305 S. CONGRESS PUD
Existing Site Survey

COMMENT REVIEW REPORT

This report includes all comments received to date concerning your planned unit development. The planned unit development will be approved when all requirements identified in this report have been addressed. However, until this happens, your planned unit development is considered disapproved.

STREET SECTION A-A'
SOUTH CONGRESS AVENUE EDGE CONDITION

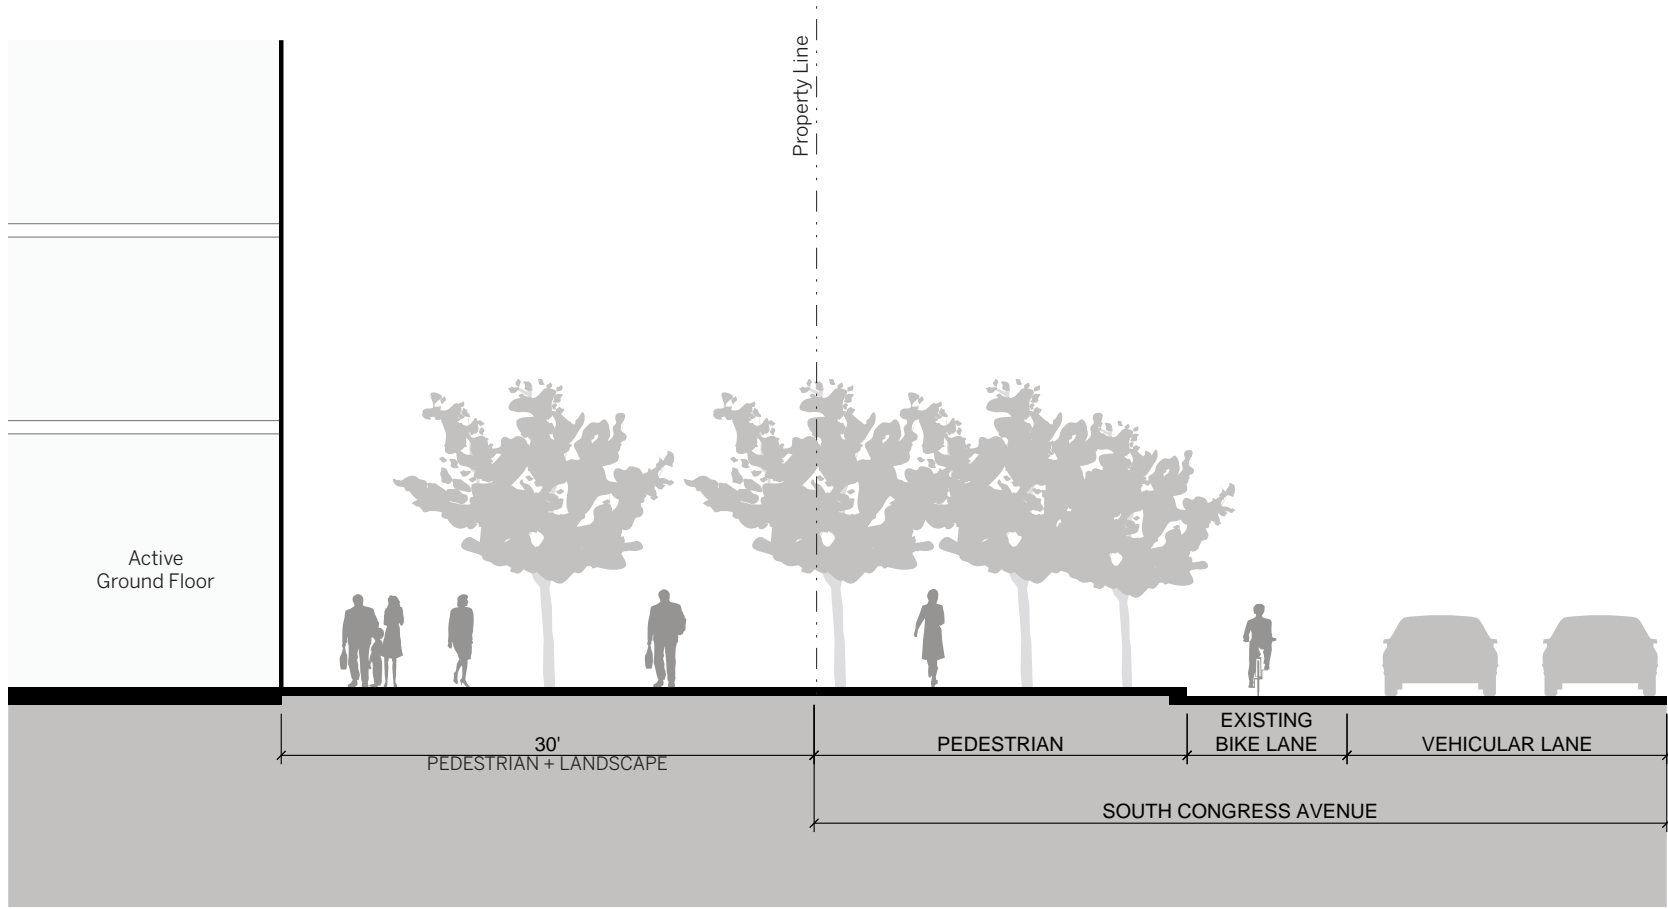
- ATD 5. Street Section A-A: No bike facility is shown in this cross section. The South Central Waterfront plan calls for **a 6'-6.5' raised bike lane behind a 2' buffer** along the east frontage of S. Congress. The ASMP identifies protected bicycle facility along Congress frontage as well. In order to meet the superior results expected from PUDs, the cross sections should at least meet the baseline set by ASMP.

Update 2: The recently installed protected bike lanes must still be included within the cross section. PUD A-A cross section should mirror South Central Waterfront Plan for S. Congress (Core Transit Corridor):

INTERNAL PVT DRIVEWAY SECTION C-C'
ENTRY STREET TYPICAL SECTION 66' WIDE

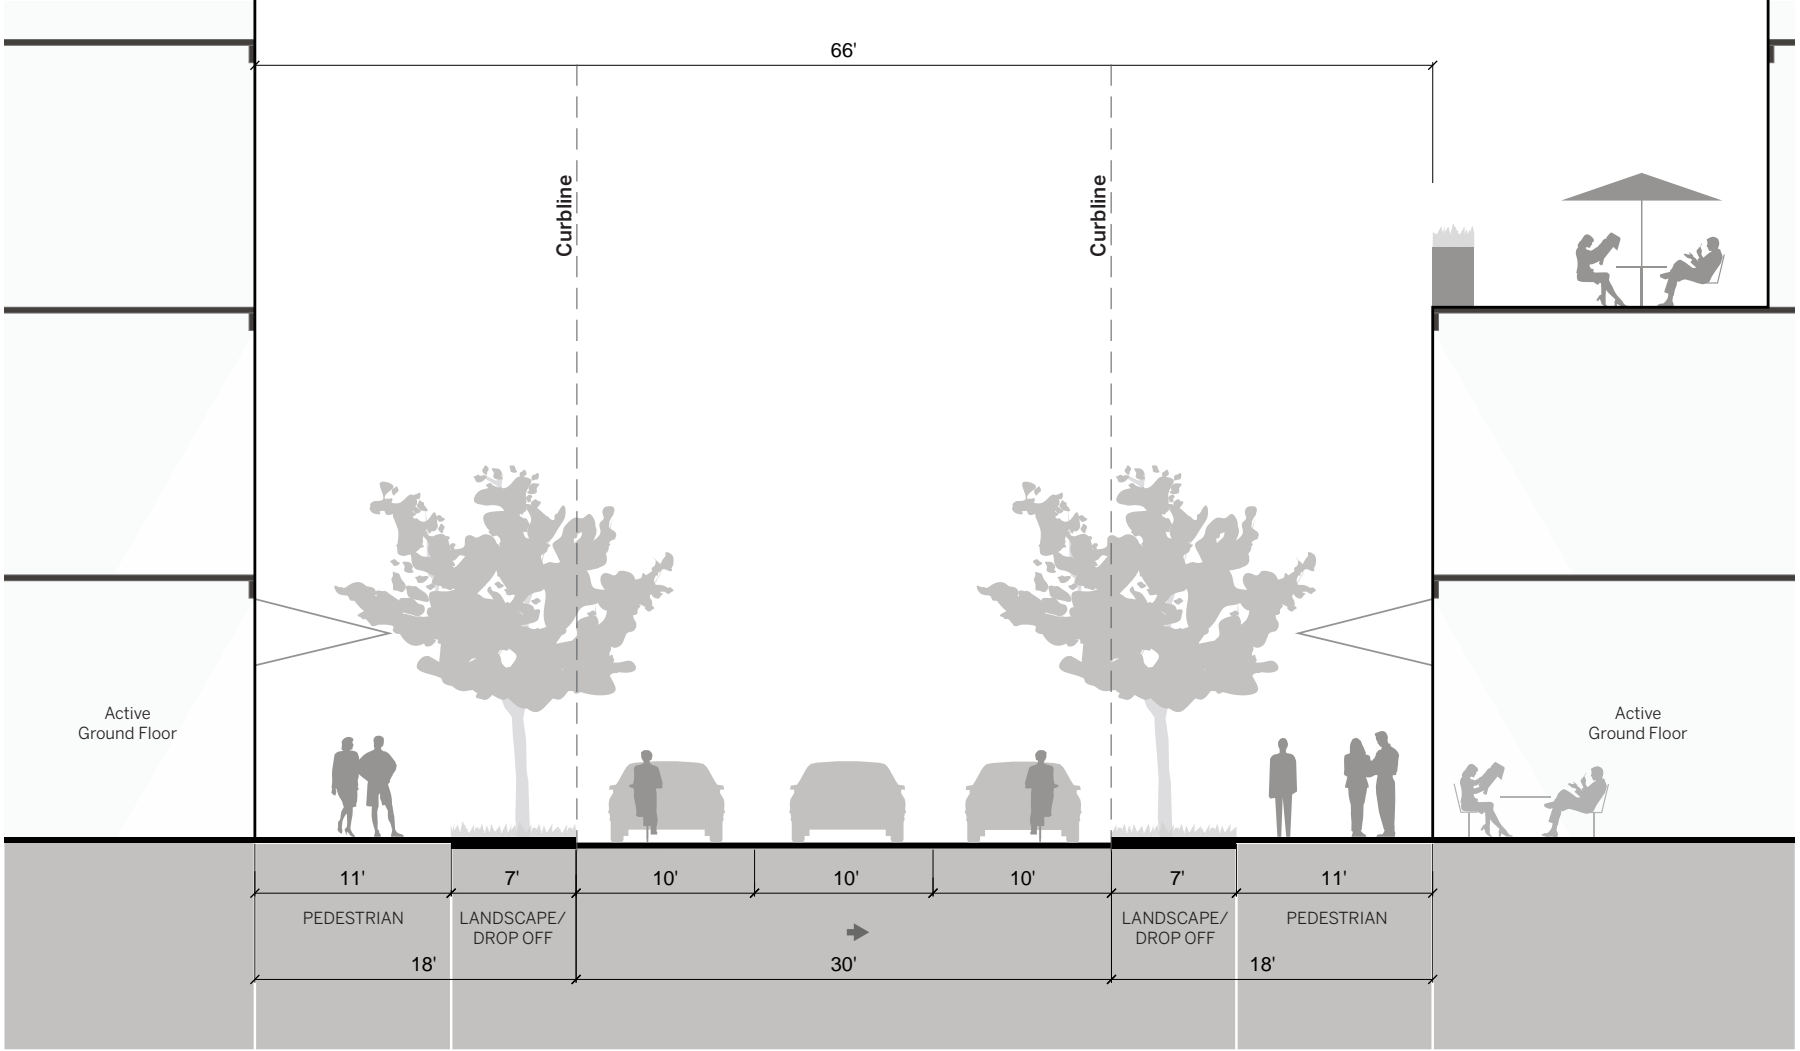
- ATD 6. Street Section C-C: ASMP calls for this to be a 2-lane street with all ages and abilities bike infrastructure. If this is planned to be a street with low volume (less than 3000 ADT), national best practice would make a simple 5' painted bike lane in each direction acceptable for this facility, which would fit within the roadway width indicated in the cross section. If higher vehicular volume is planned, a protected bicycle lane would be necessary to be an all ages and abilities facility.

Update 2: If 5000+ VTD are anticipated, protected bike lanes are required. The South Central Waterfront Plan requires min. 5' bike lanes (see "Local Street" cross section from SCWP below):

INTERNAL PVT DRIVEWAY SECTION D-D'
SHARED STREET TYPICAL SECTION 66' WIDE

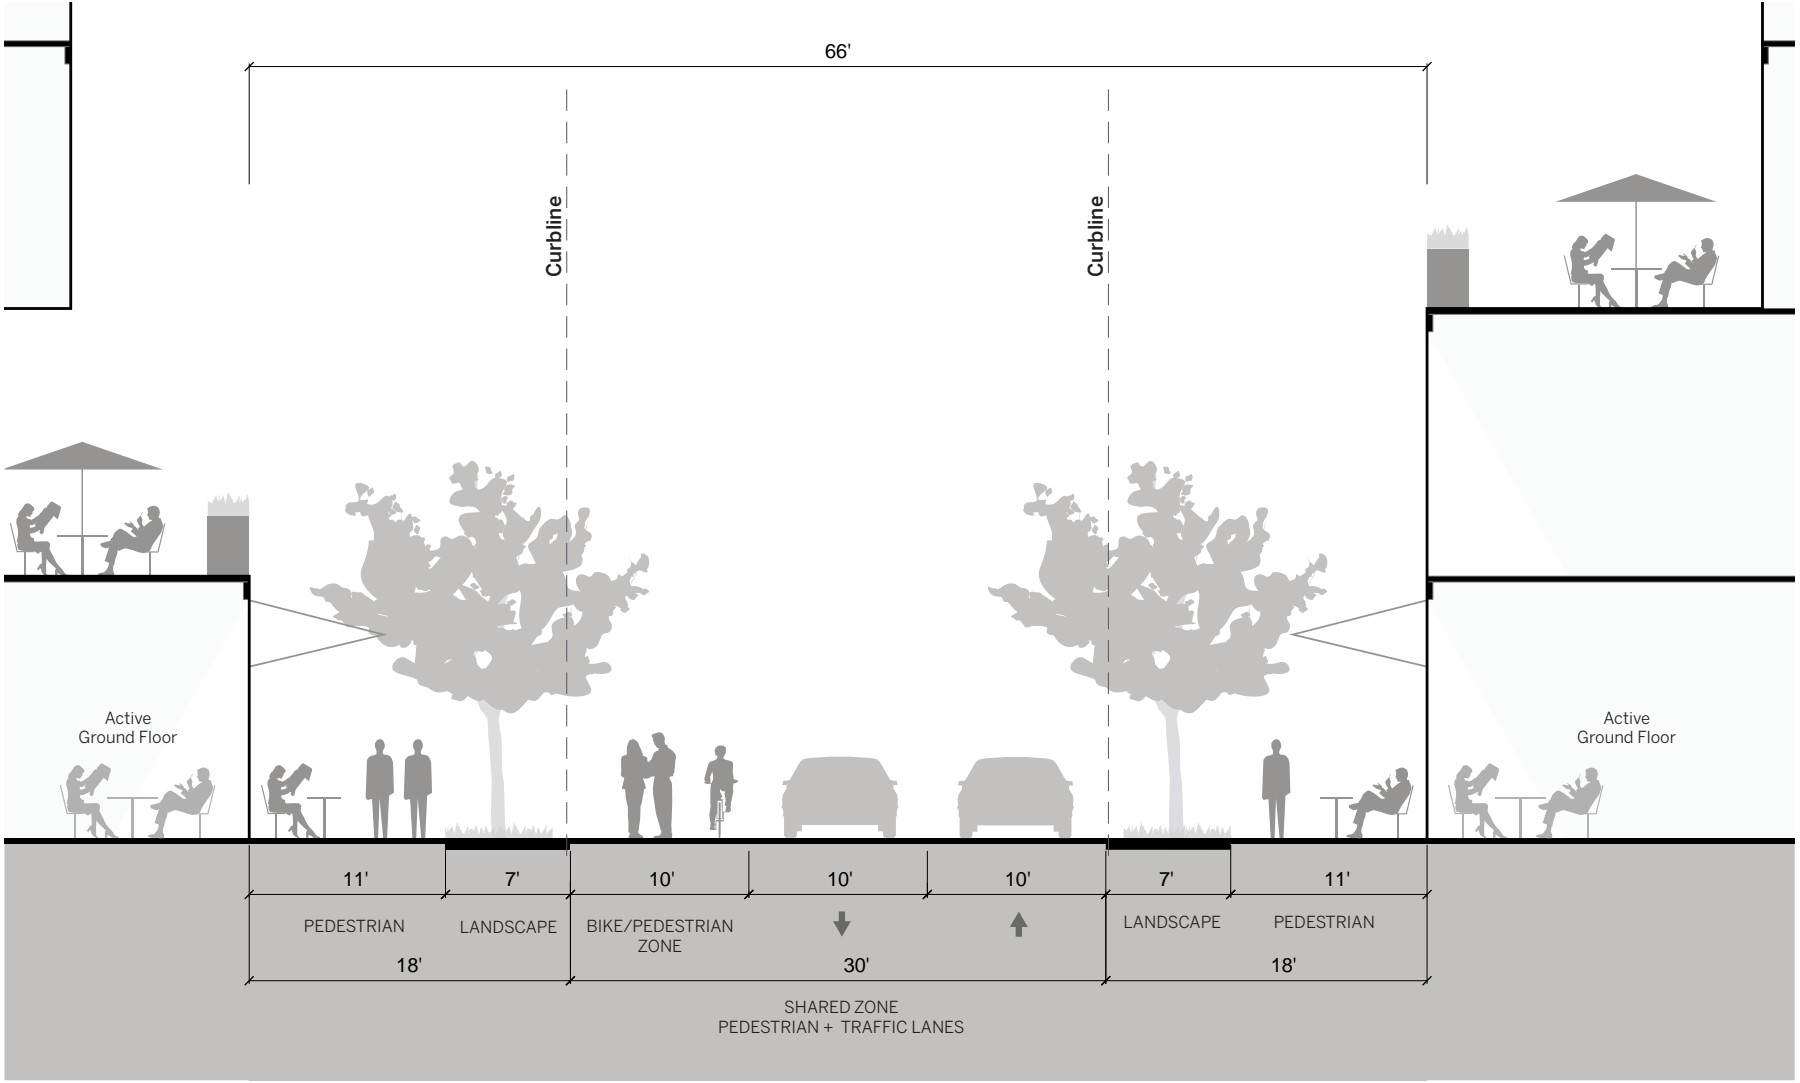
- ATD 7. Street Section D-D: ASMP calls for this to be a 2-lane street with all ages and abilities bike infrastructure. If the space shown in the cross section is intended as a two-way cycle track, it should be shown that way with vertical separation from vehicular travel space. If that is the

case, 10' would be very constrained given the context of a possible future pedestrian bridge. Recommend 12' minimum width plus a barrier.

Update 2: The SCWP identifies a 12' cycle track with 1' buffer as needed for this shared street. Comment pending further internal review.

PEDESTRIAN WALKWAY TYPICAL SECTION E-E' 45' WIDE

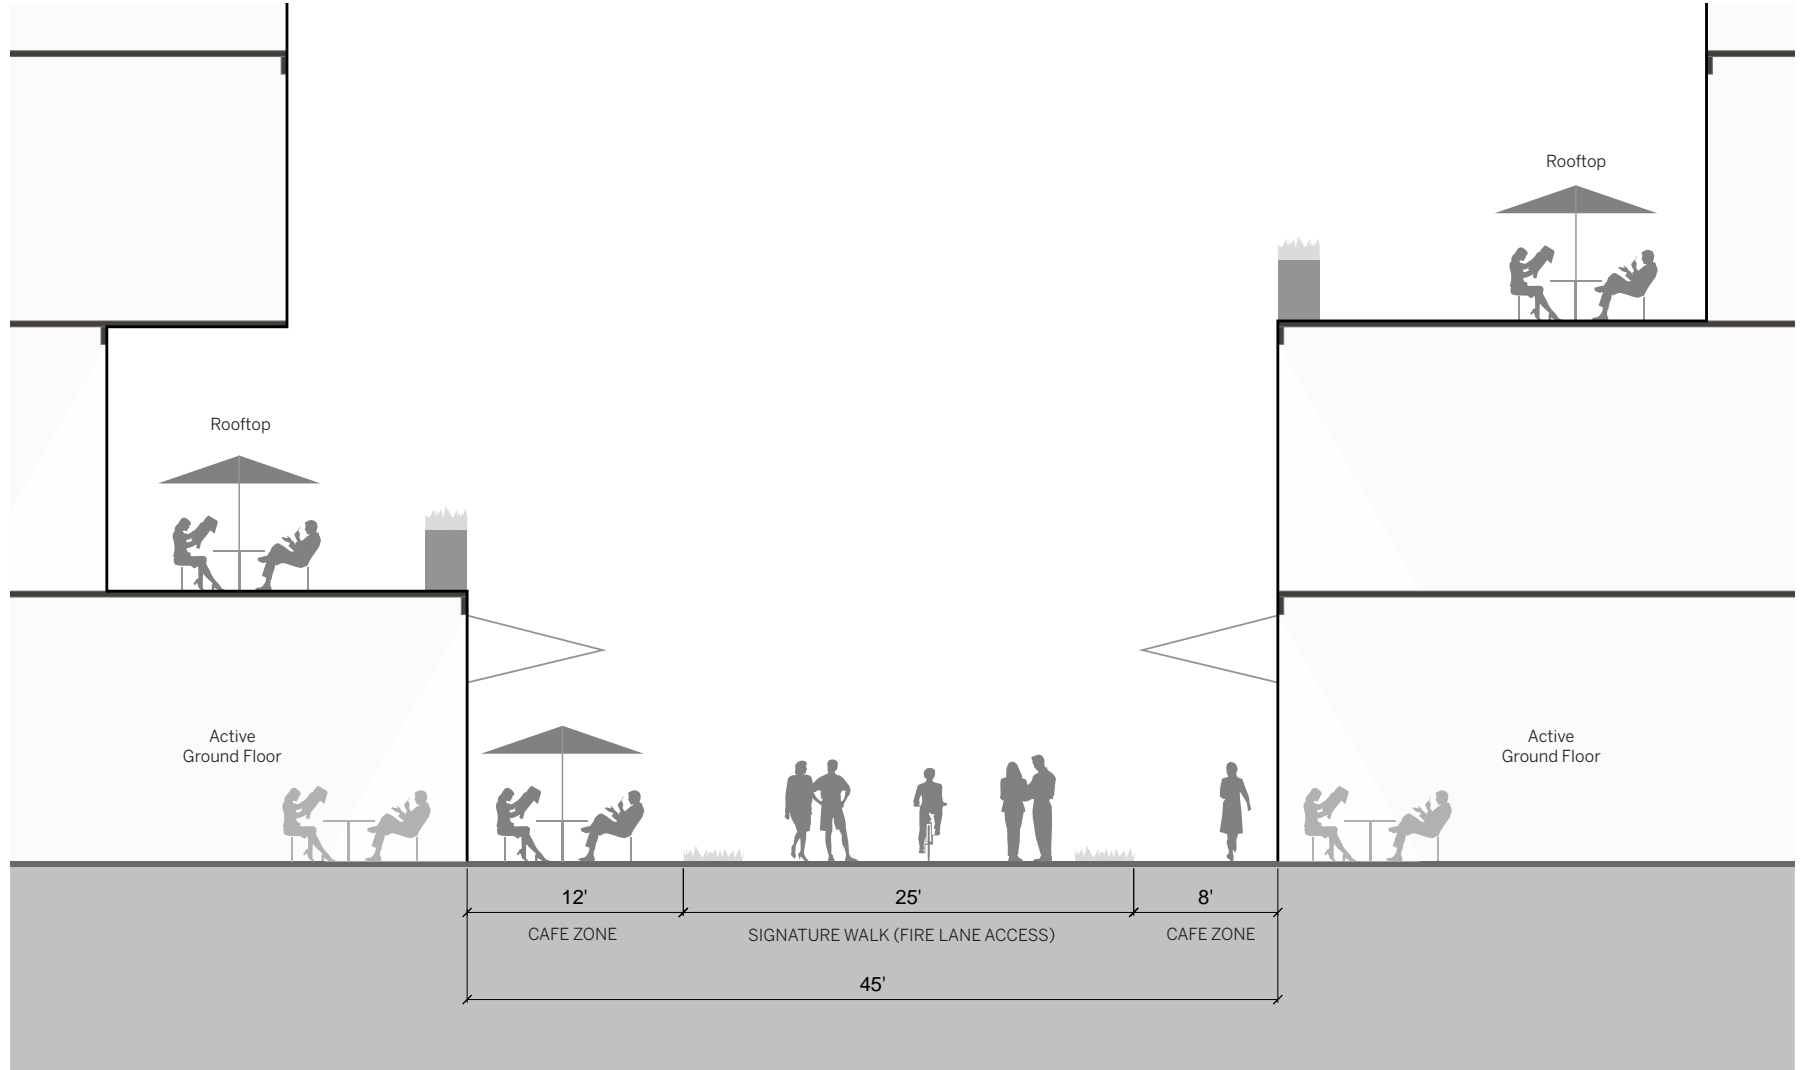
- ATD 8. Street Section E-E: There should be actual tree zones identified on this cross section as this would otherwise be a wide unshaded area. If this will be used as fire access, AFD will want 25' clear at designated deployment zones, but trees could be planted inside this 25' but outside of those small deployment zones. It needs to be made explicit in the exhibit that this street section will be closed by bollards so that it does not become an extension of the shared street to the east or used for loading zones.
